ADDENDUM 002

DATE: July 23, 2025
COMM NO: 24058.001
PROJECT: VINTON War Memorial Renovation

TO: All Bidders
FROM: Shawn Emmons
RE: Addendum No. 2

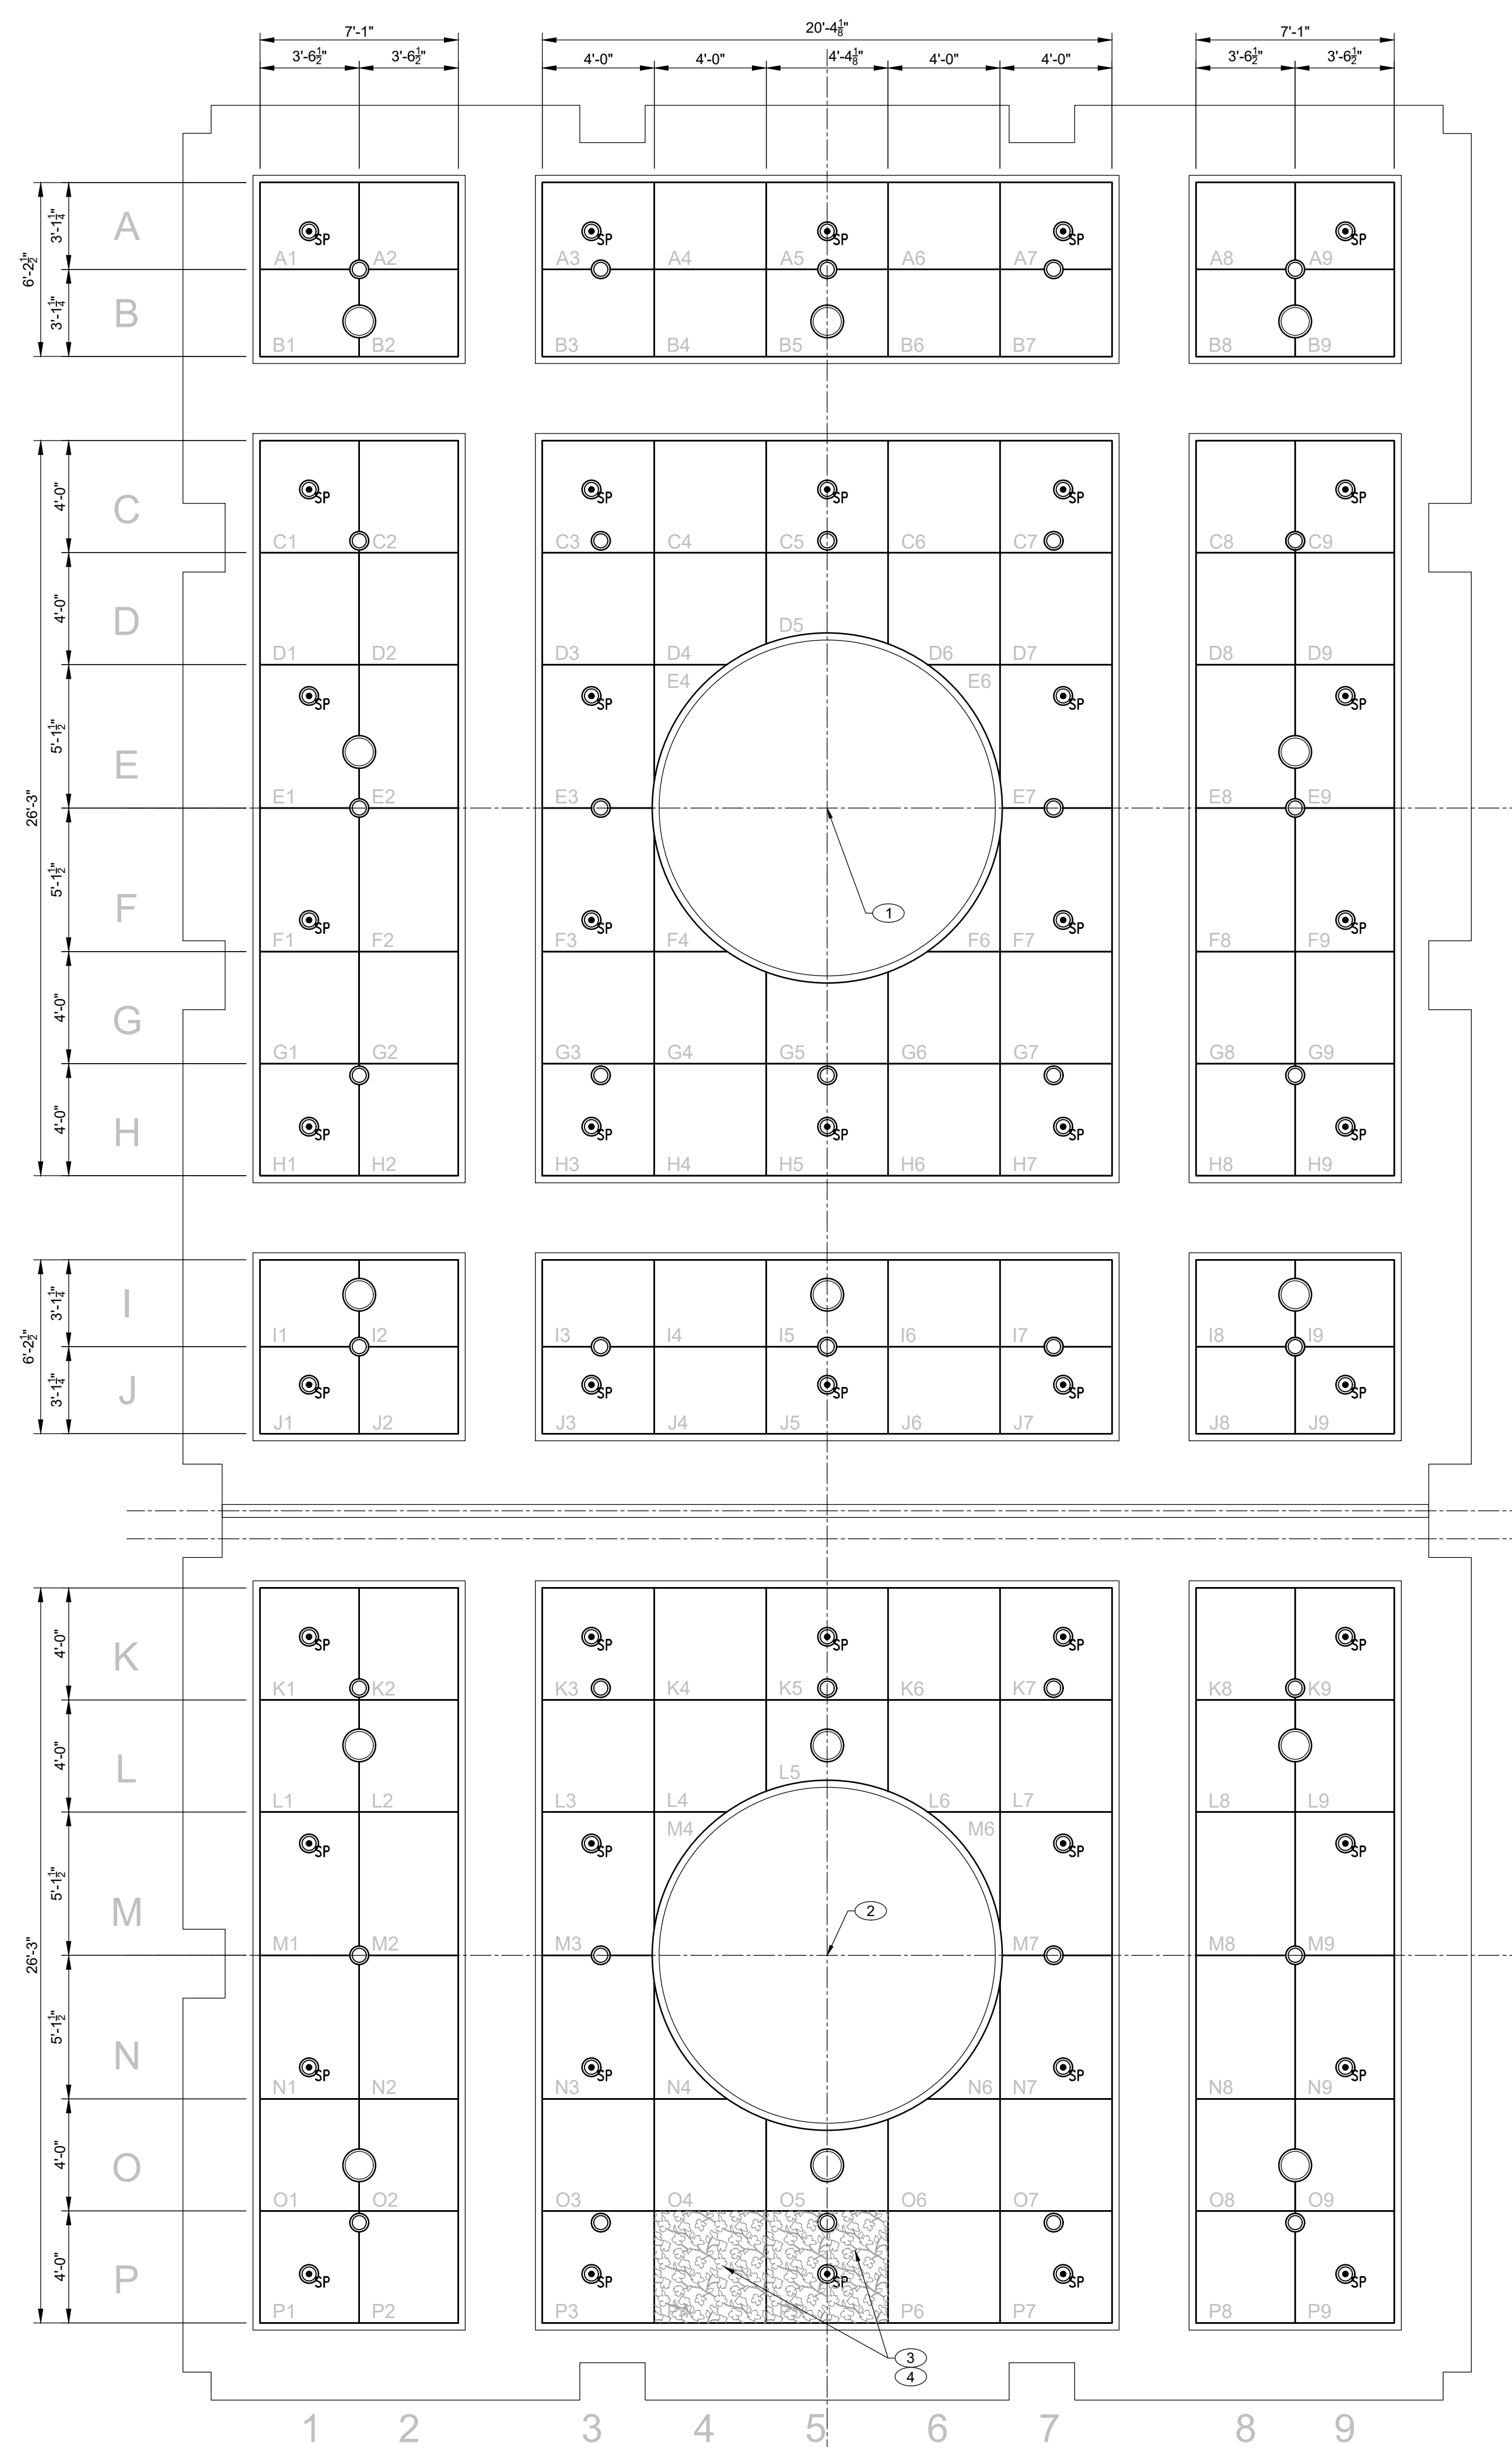
REPLACE sheet dated JUNE 20, 2025 with Sheet A7-4 identified with Delta 2, ADD NO 2, dated 7/23/25.
Plan Notes 4 & 5 revised to indicate that metal panels, cables, & cable connectors shall be OWNER-FURNISHED, CONTRACTOR-INSTALLED.

- 4 METAL PANELS - PROVIDE SIZES INDICATED W/ CUSTOM "DOGWOOD" PATTERN & ROUND CUTOUTS FOR CEILING DEVICES, SHOP FABRICATED NOT FIELD CUT.
ALL METAL PANELS SHALL BE OWNER-FURNISHED, CONTRACTOR-INSTALLED.

- 5 CABLE SUPPORT SYSTEM SHALL CONSIST OF 3/32" 7x7 GALVANIZED STEEL CABLE W/ GR SERIES CABLE GRIPPER CONNECTOR THAT IS ADJUSTABLE WITH SIDE EXIT. PROVIDE SIX POINTS OF CONNECTION FOR EACH PANEL, ONE AT EACH CORNER, & ONE AT THE MIDPOINT OF TWO OPPOSING SIDES. GRIPPER SHALL BE INTEGRATED INTO THE METAL PANELS/ SHOP FABRICATED PRIOR TO APPLICATION OF METAL PANEL FINISH. BASIS-OF-DESIGN PRODUCT BY PENDANT SYSTEMS. WWW.PENDANTSYSTEMS.COM
ALL CABLES & CABLE CONNECTORS SHALL BE OWNER-FURNISHED, CONTRACTOR-INSTALLED.

COMMISSION No.
24058.001
SHEET
A7-5

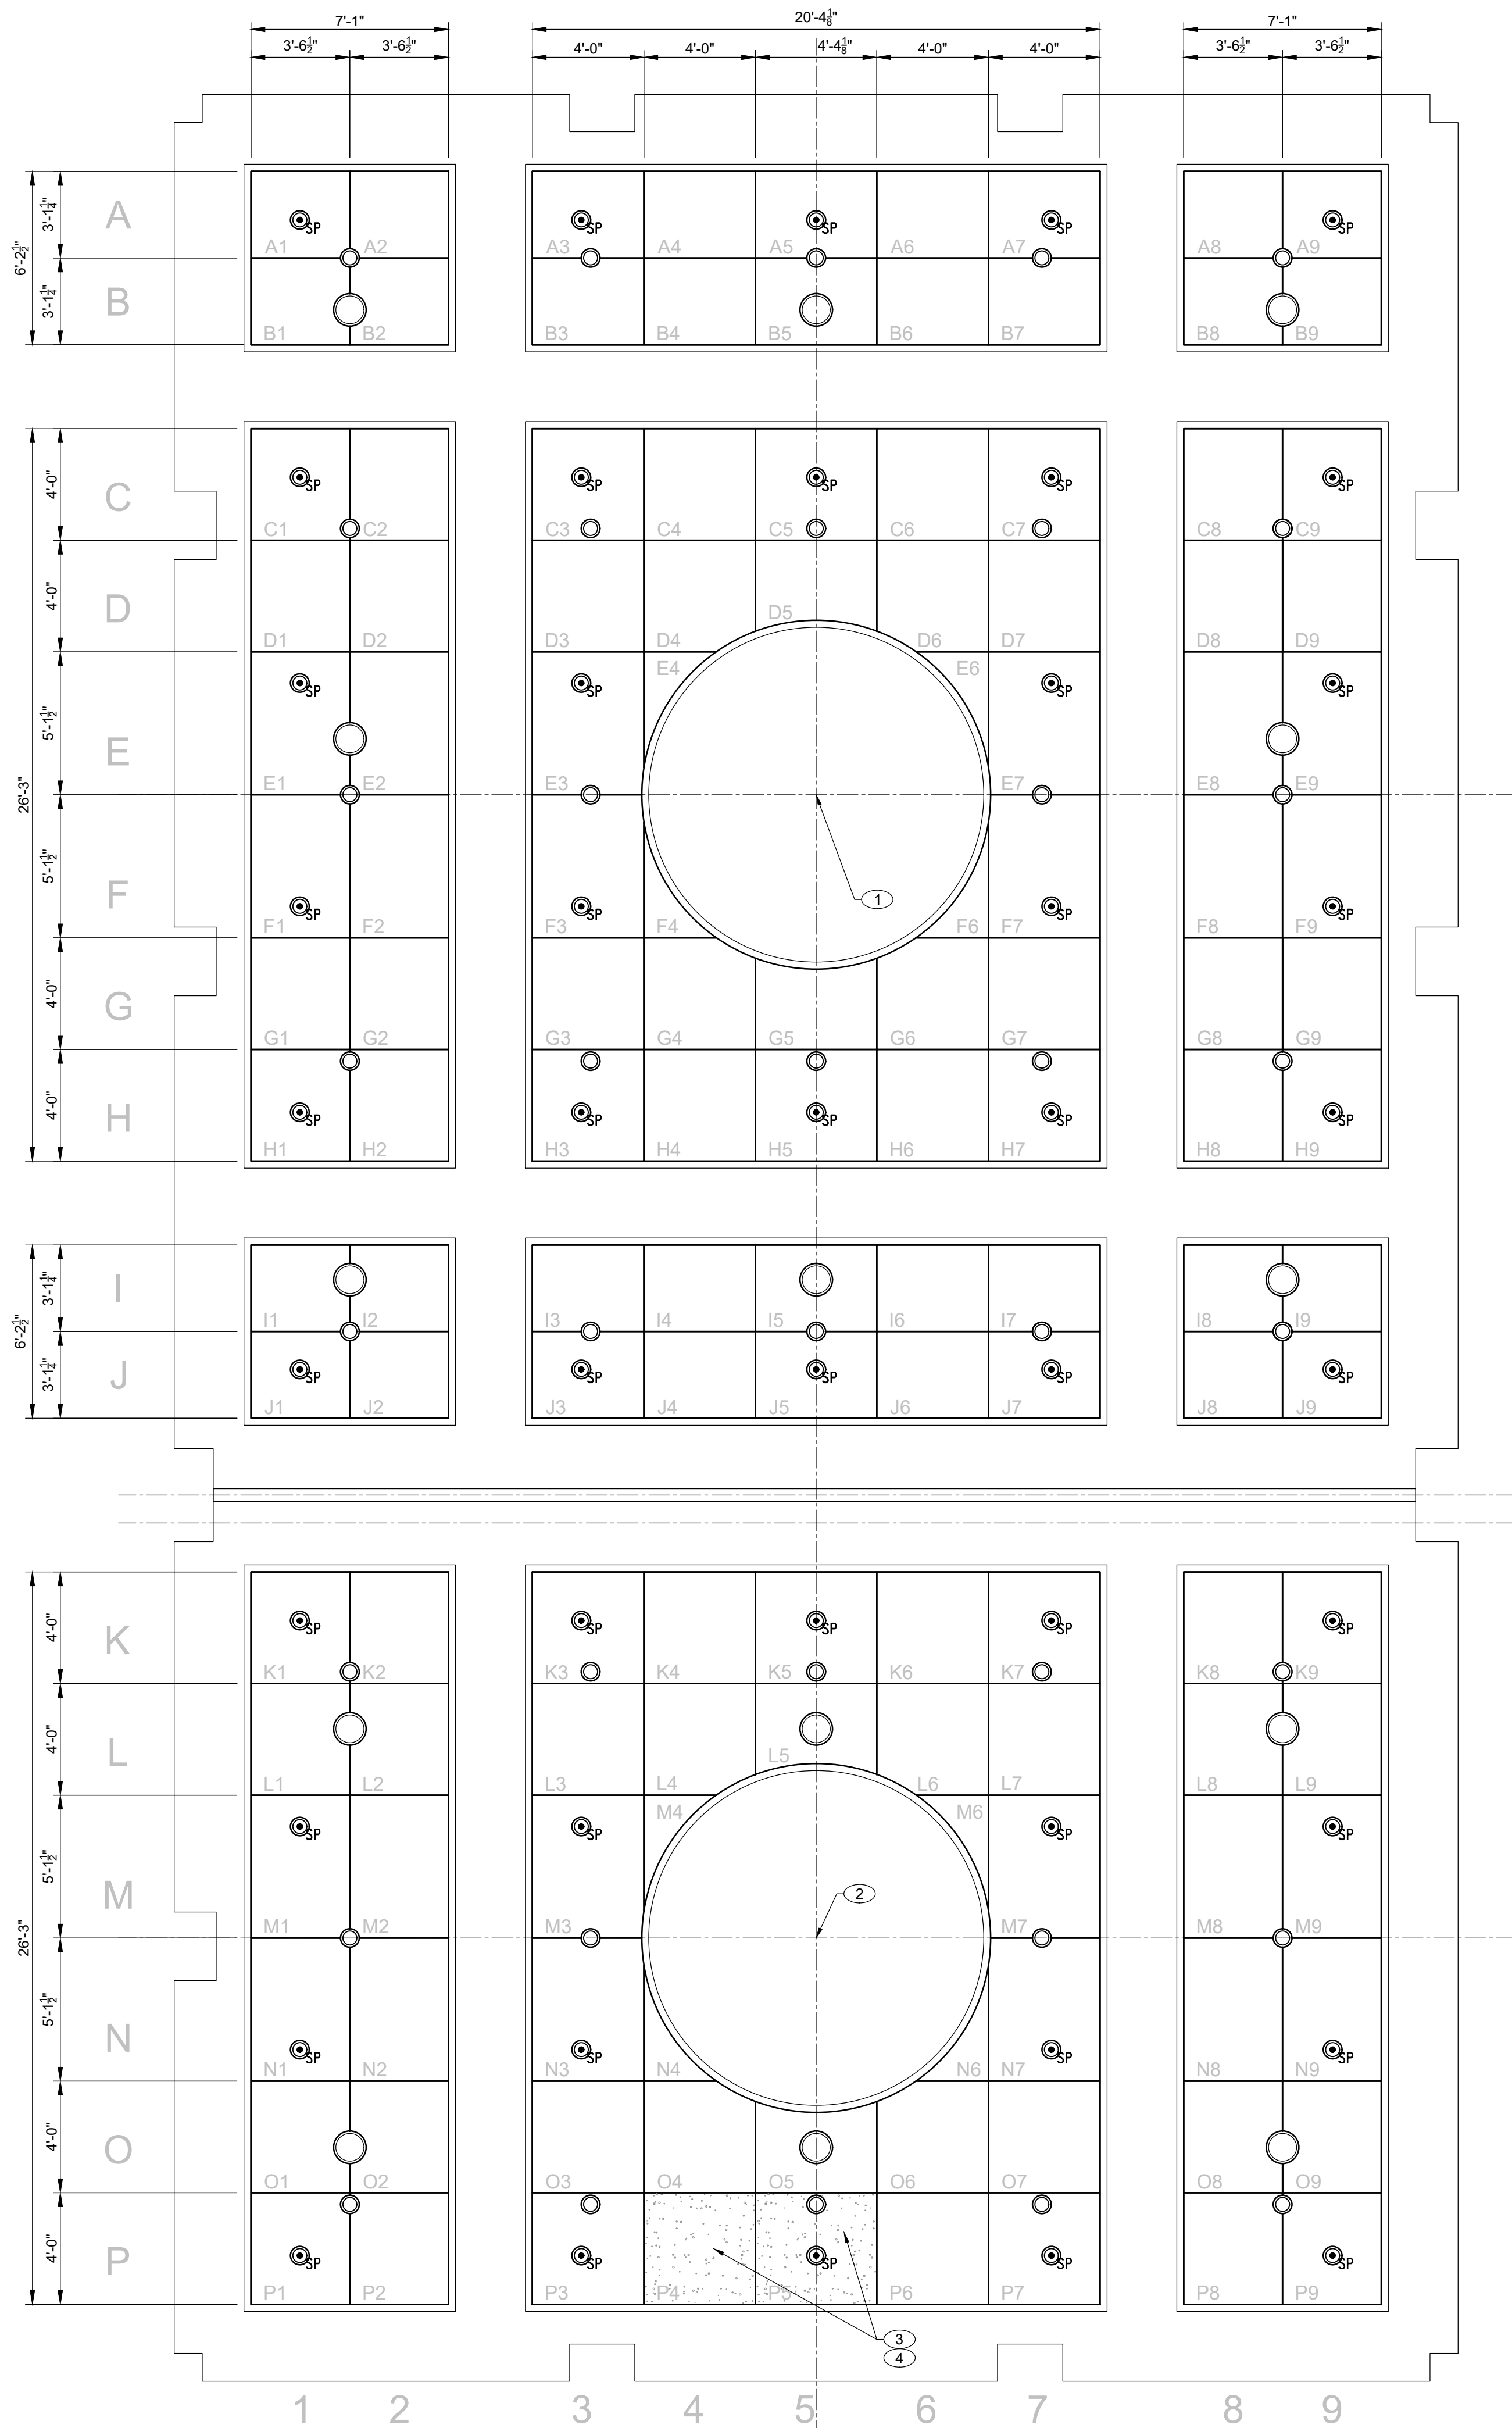
REPLACE sheet dated JUNE 20, 2025 with Sheet A7-5 identified with Delta 2, ADD NO 2, dated 7/23/25.
Plan Note 4 revised to indicate that acoustical panels shall be OWNER-FURNISHED, CONTRACTOR-INSTALLED.

- CEILING NOTES**
- 1 CENTER POINT OF NORTH BALLROOM 112.
ALL CEILING DIMENSIONAL LAYOUTS IN 112 ORIGINATE FROM THIS POINT.
 - 2 CENTER POINT OF SOUTH BALLROOM 109.
ALL CEILING DIMENSIONAL LAYOUTS IN 109 ORIGINATE FROM THIS POINT.
 - 3 3/4" ACOUSTICAL PANELS - SCREW ATTACH TO LIGHT GAGE FRAMING ABOVE AT 12" SPACING.
BASIS-OF-DESIGN: COLOR 170 SMOKE GRAY BY RENAISSANCE LIGHTING, ROANOKE VA
CONTACT: TROY COOK, PRESIDENT, 540.342.1548
 - 4 ACOUSTICAL PANELS - PROVIDE SIZES INDICATED W/ CUSTOM HOLE PATTERN & ROUND CUTOUTS FOR CEILING DEVICES, SHOP FABRICATED NOT FIELD CUT.
ALL ACOUSTIC PANELS SHALL BE OWNER-FURNISHED, CONTRACTOR-INSTALLED.
